ADDENDUM No. 1

ITB No. 4519

North Fifth Avenue Reconstruction

DOWNTOWN DEVELOPMENT AUTHORITY - CITY OF ANN ARBOR	
DETOUR PLAN	SCALE: NOT TO SCALE INCH
DRAWING NO. C1.01	SHEET NO. ___ OF ___

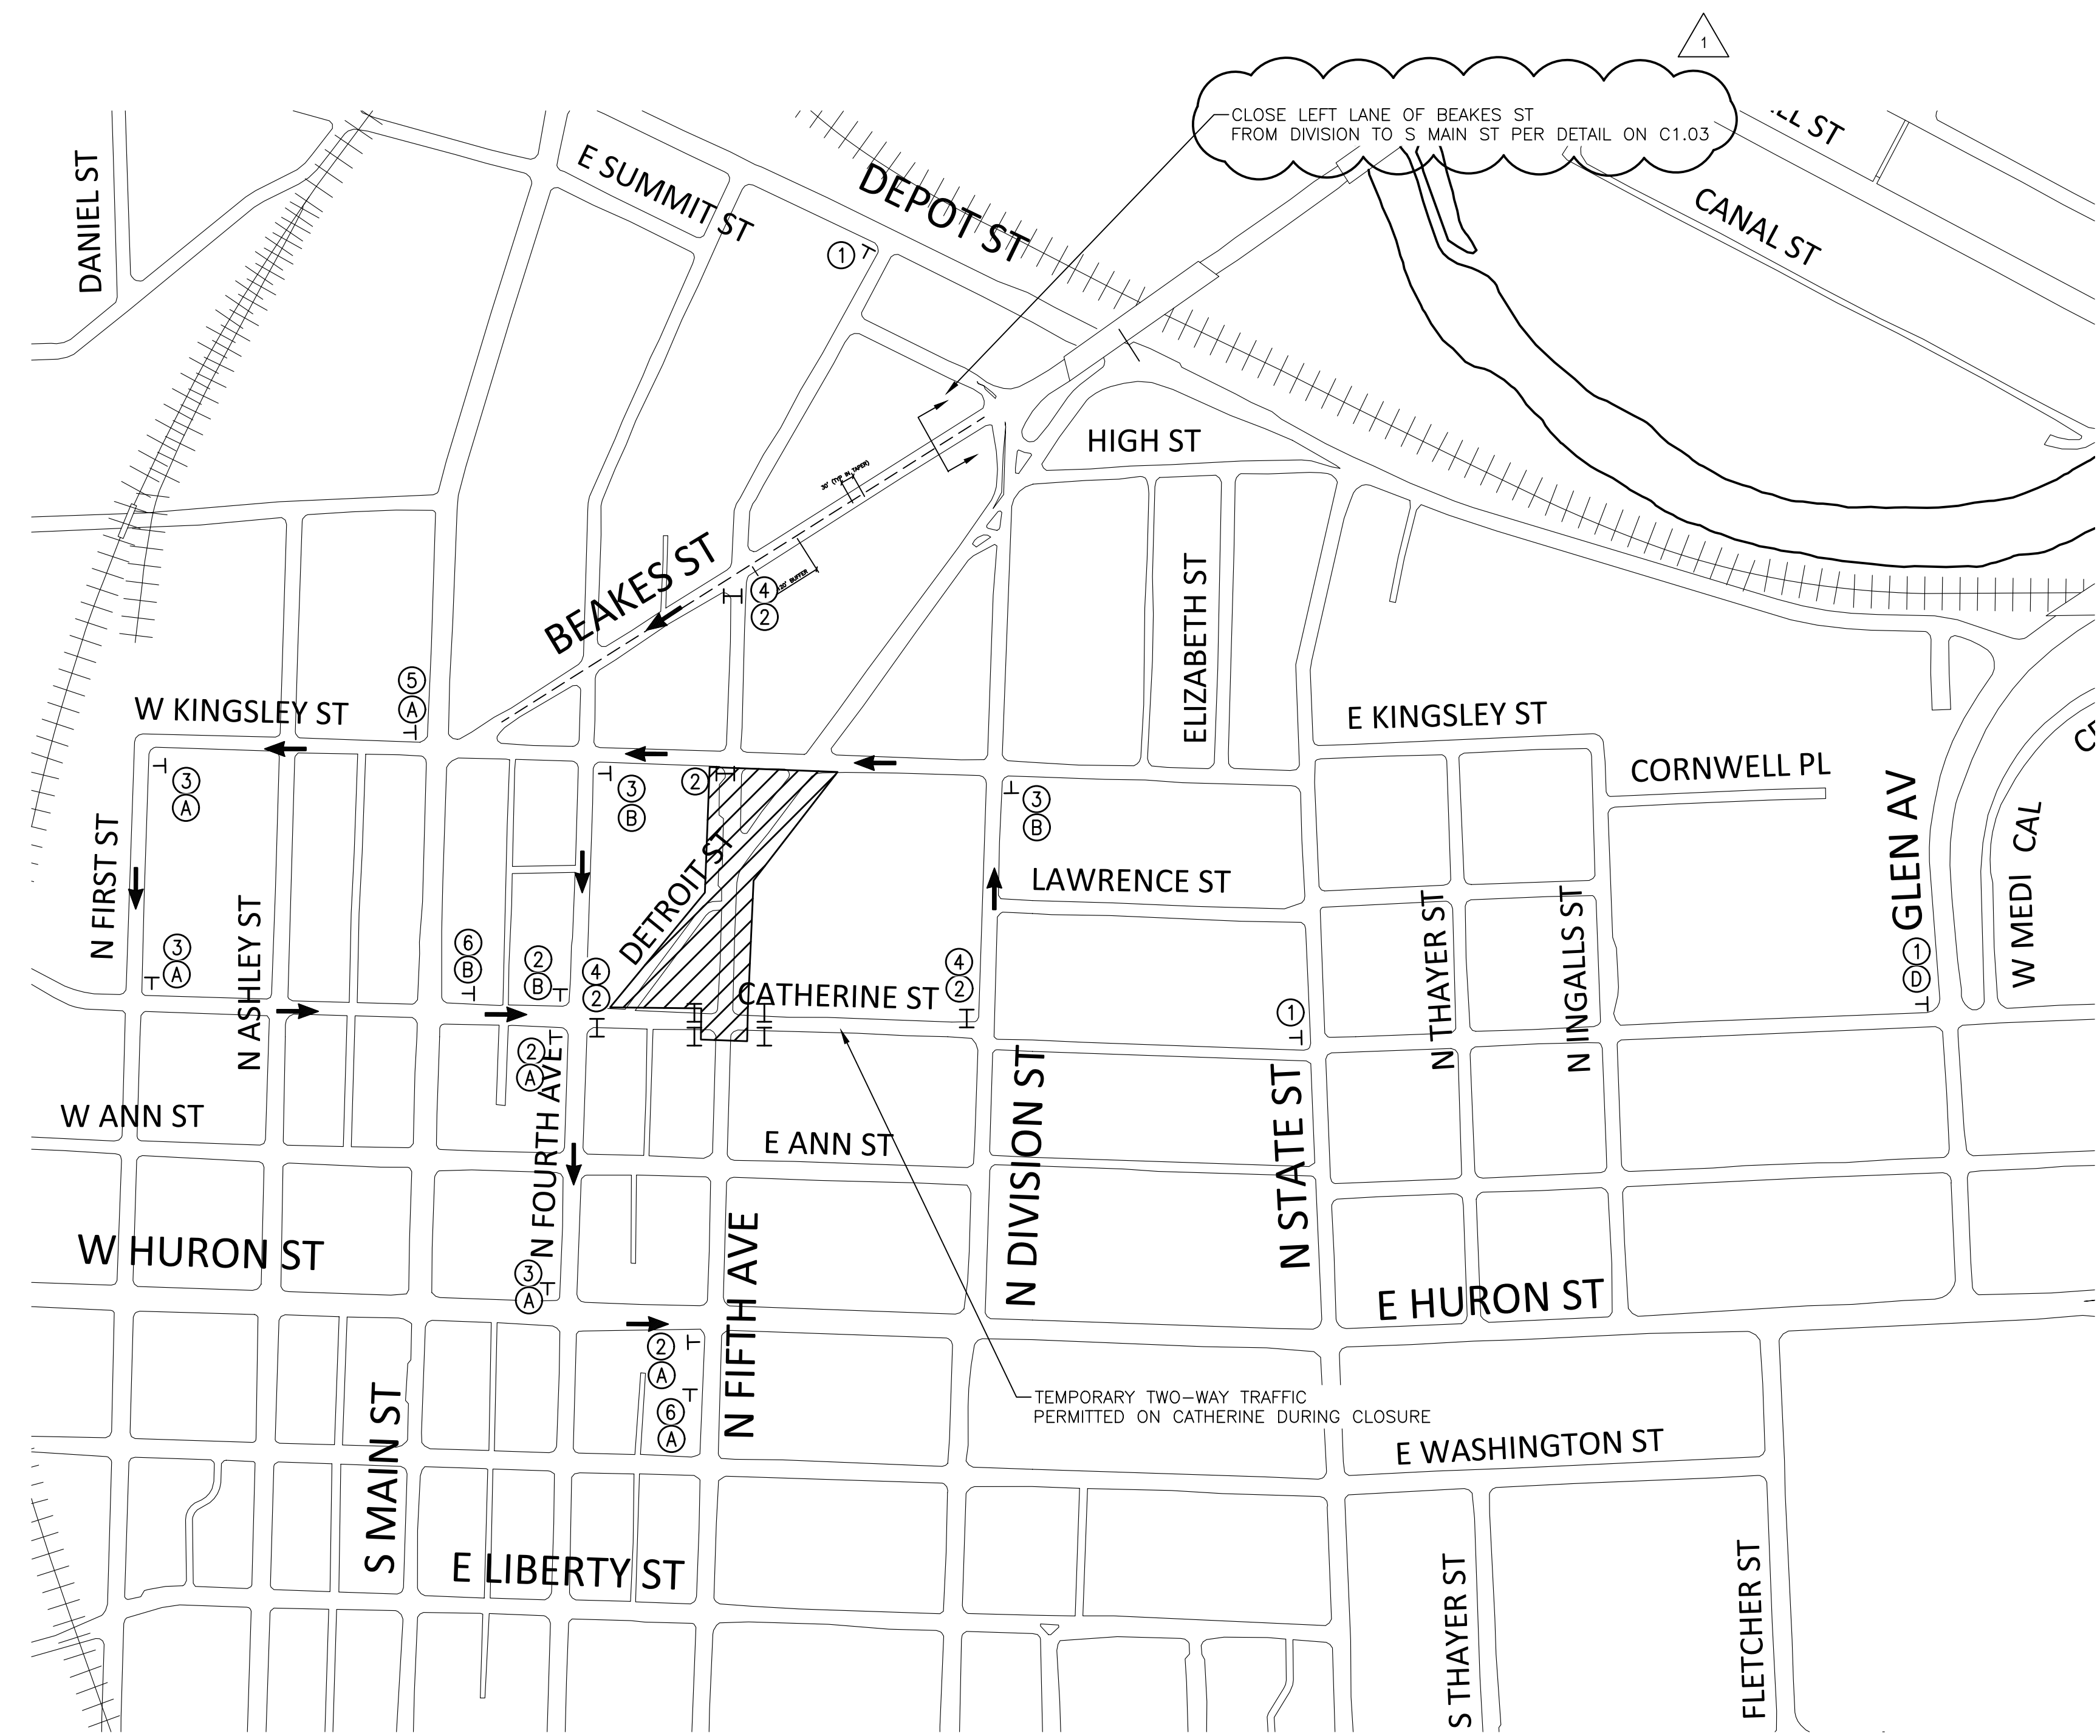
5. It appears that there is no a traffic control plan/staging plan for the proposed water main work and interconnections at the various intersections, Kingsley Street and the southern leg of Detroit Street. Will the City be issuing staging/traffic control plans for these various stages of water main work?

- Response: See attached plans.

SCALE NONE	INCH []
DRAWING NO. C3.00	
SHEET NO. ___ OF ___

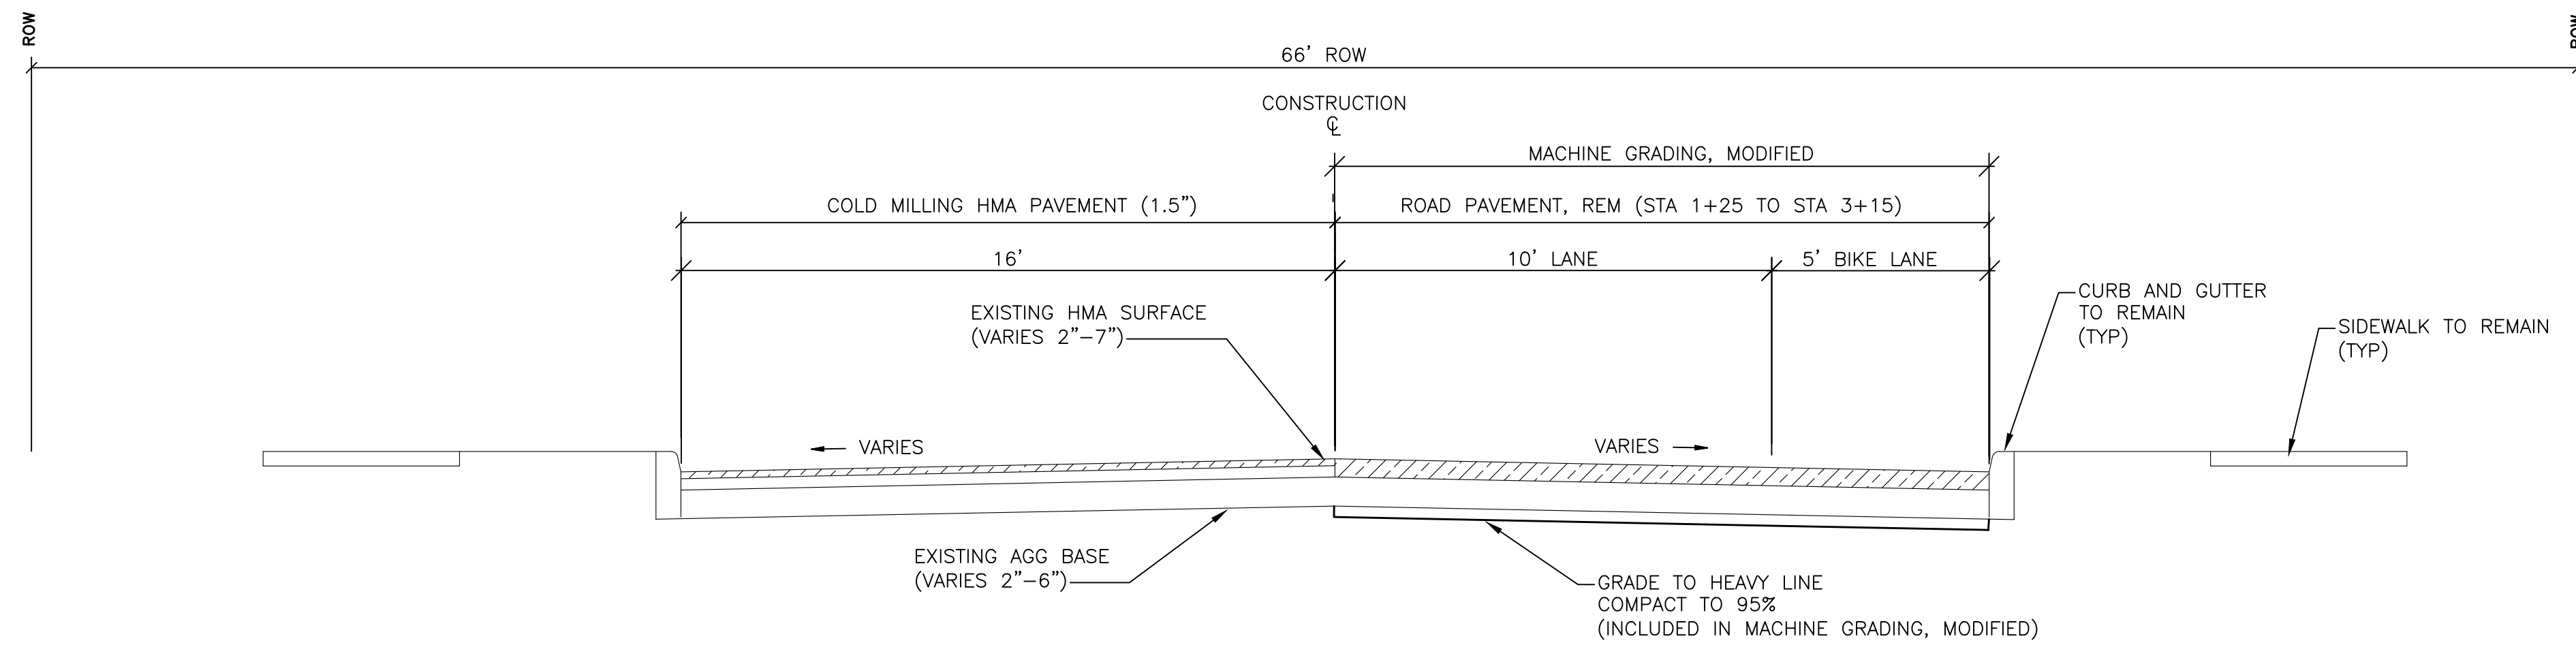
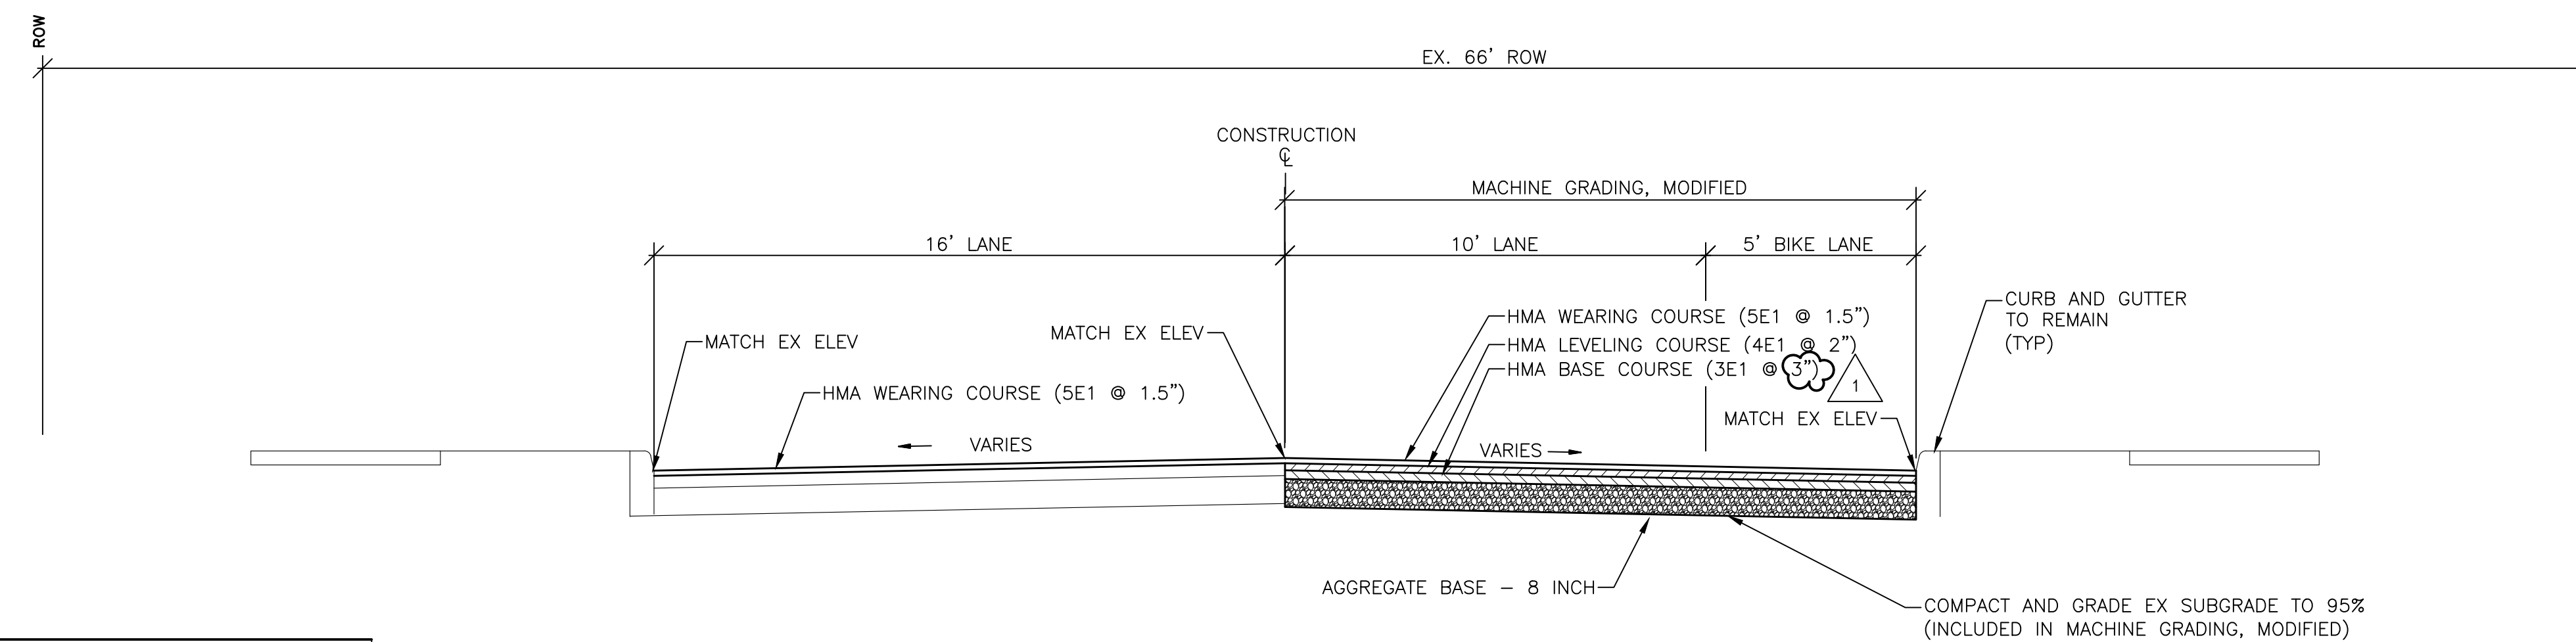
3. Does the pay item for “Temporary Line Stops” include the necessary items for surface restoration (pavement, aggregate, etc.), or will these items be paid for separately? The special provision makes reference to the removals, but does not directly address the restoration. Please clarify.

9. Will the road(s) require temporary surface(s) as we make the required interconnections in the intersections and between mainline testing stubs? If so, how will this work be paid for? Do you have a required temporary pavement cross section?

- Response: Pavement cross section replacement will be paid for separately. A detail has been provided on C3.0, noting applicable pay items.
4. Please clarify if ANY of the proposed improvements that are scheduled to be performed OUTSIDE of the typical Machine Grading Limits (ROW to ROW) will be included in the stationing for the Machine Grading Pay Item and/or covered in the other typical pay items (pavement removal, agg base, HMA, concrete sidewalk, etc.). Specifically, the hydrant extension on Fifth Street (STA 7+22) appears to extend past the typical Machine Grading pay limits. How will removals and restoration be paid for outside of the typical Machine Grading pay limits?

- Response: It is likely that a temporary surface will be required to maintain traffic. A cross section detail and pay items for temporary pavement have been added to the plans.

FIFTH STA. 07+20 HYDRANT LEAD REPLACEMENT

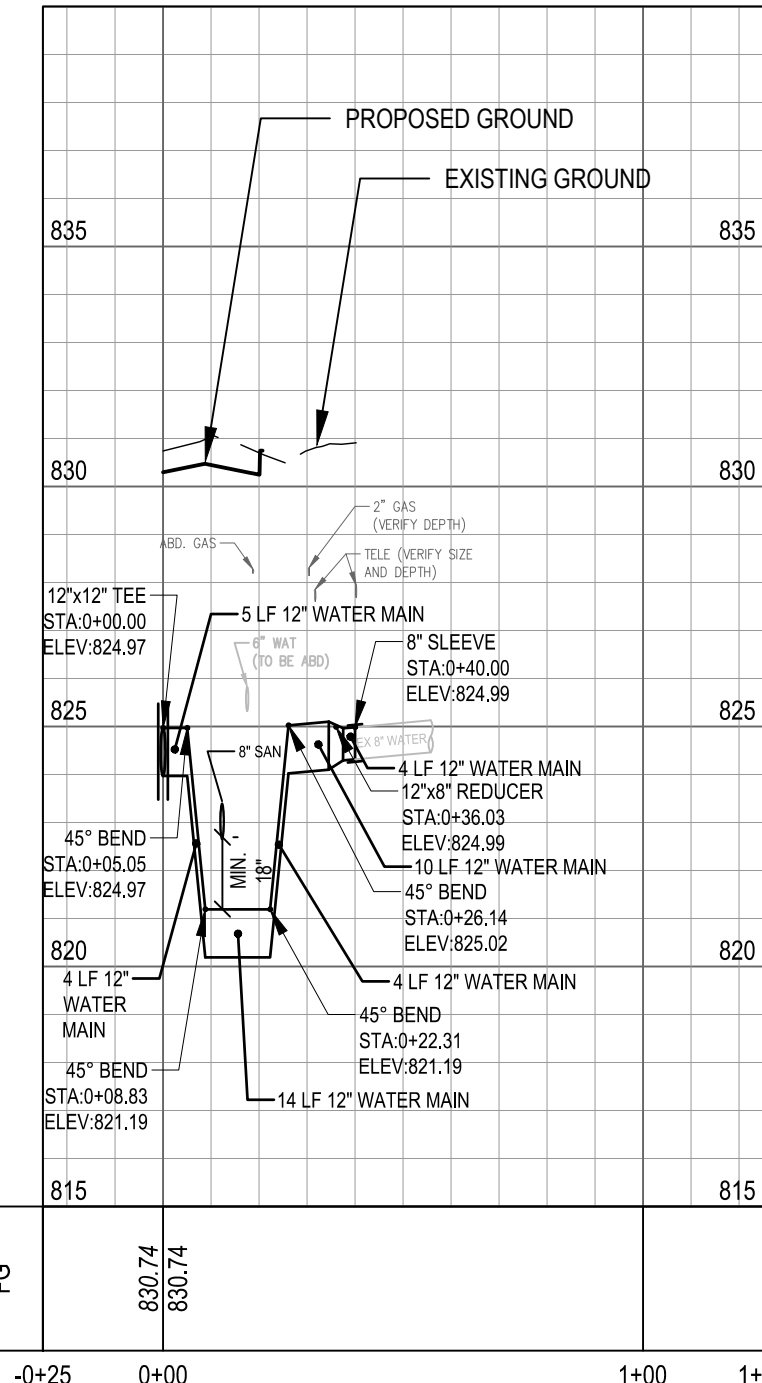
6. Please clarify the water main abandonment limits for the existing main that runs parallel to the proposed hydrant at STA 07+22 on Fifth. The plans are not clear as to the intent of this work.

- Response: This hydrant will not be replaced, but the lead up to the valve will be upsized per the revised, attached plan.
7. Do you intend on leaving unconnected legs of proposed water main (dead end “stubs”), as required, to allow for a traditional phased ROW improvements? We need to get an idea of what will be REQUIRED by the City in relation to the various water main improvements for each street so that we can marry the water main phasing and scheduling to the ROW improvement phasing.
